# Access Compliance Report

## Public Rights-of-Way

### (Pedestrian Signals)

Intersection ID: N/A	Main Street:	Cross Street: N/A	Location: N/A
ADA ID: 93F63F1FE34B	Signal Type: One Push Button-Non APS	Overall Compliance: No	Severity Score: BTN 1: N/A BTN 2: N/A No BTN: N/A
Codes/Mitigation Info/Possible Solution		Field Measurements/Component Compliance

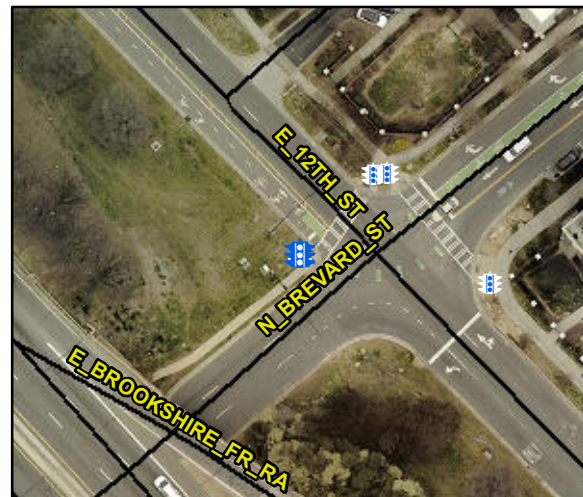
PROW/ADA: R406.2, R404.7.3

Possible Solutions: Provide Push Button Extension.
